Subject: PET 1337: 1508 Line Modification

Stepstone to Green Hill Upgrade Project

Map Sheet 8 of 9

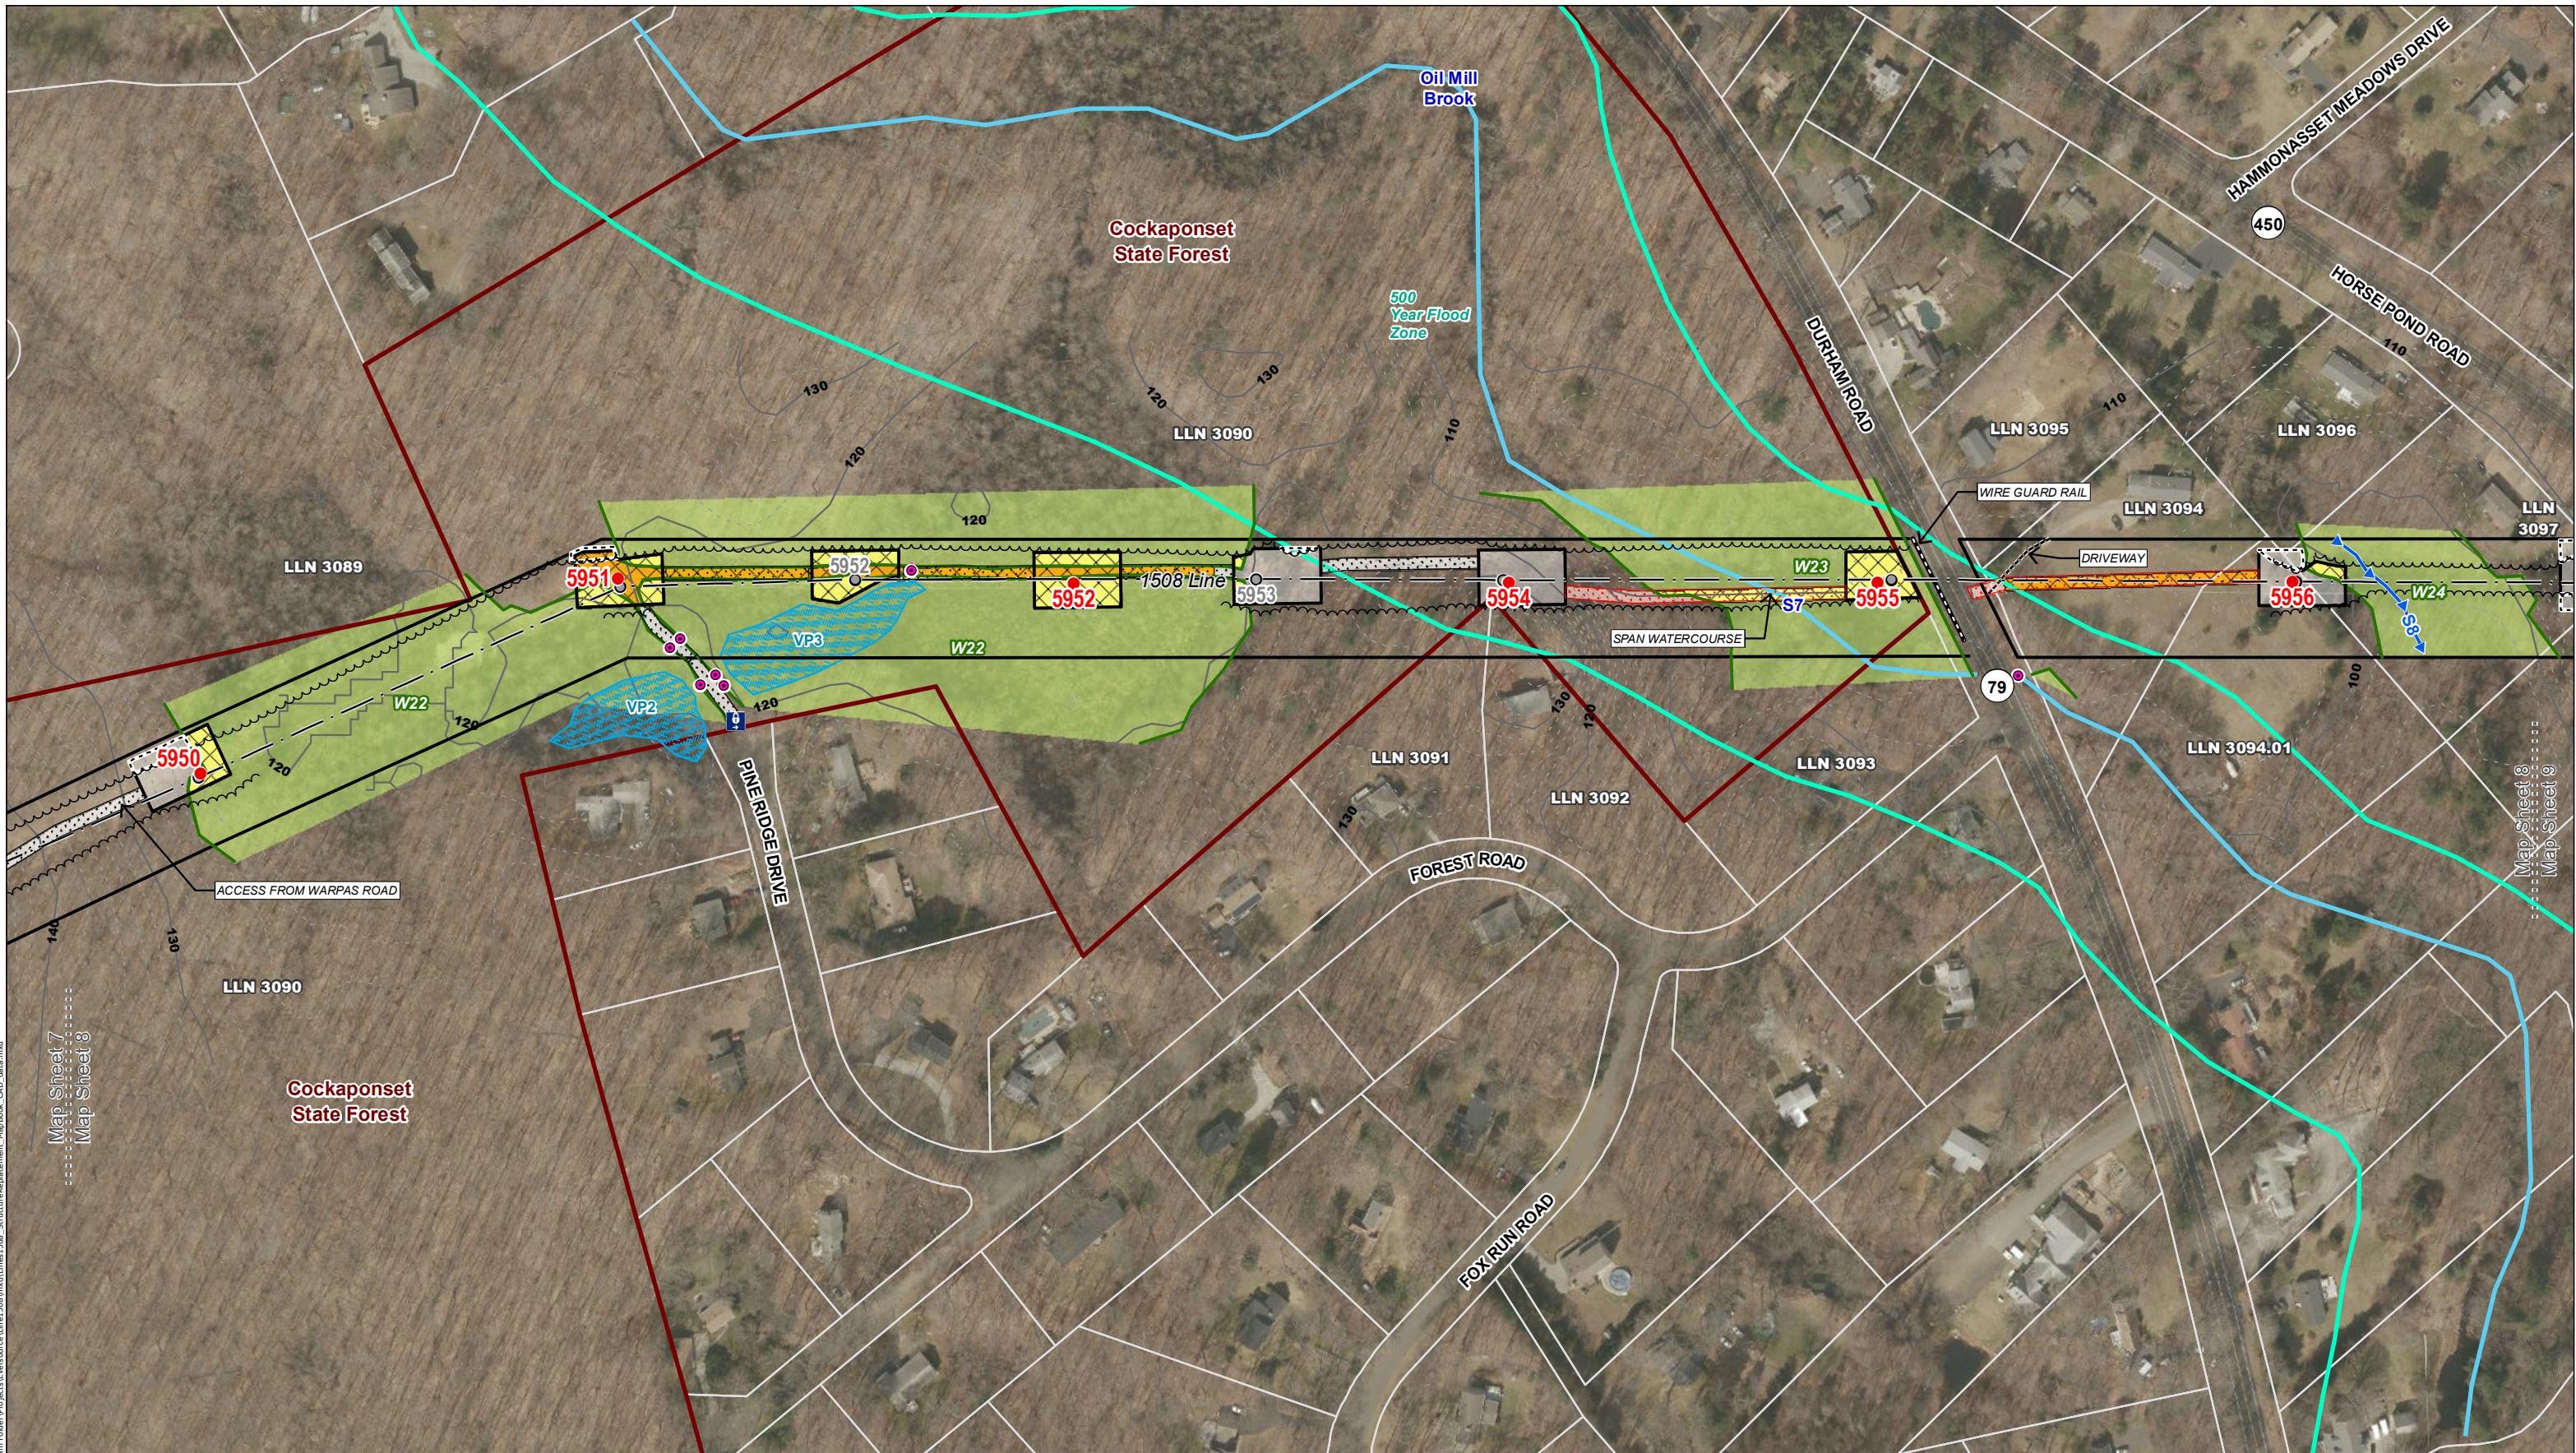
Dear Melanie Bachman:

Eversource is requesting approval from Council staff to modify its access to structure 5955. In order to improve the safety and constructability of the work area, the Project is proposing to access structure 5955 via temporary matting across a wetland from adjacent structure 5954. It has been determined that the original proposed access off of Durham Road (Route 79) will create an unacceptable safety risk, due to the close proximity of the construction, and construction access, to the busy state road. The modified access will result in approximately 8,225 square feet of temporary impacts to wetland W23. Please see the attached revised mapsheet 8.
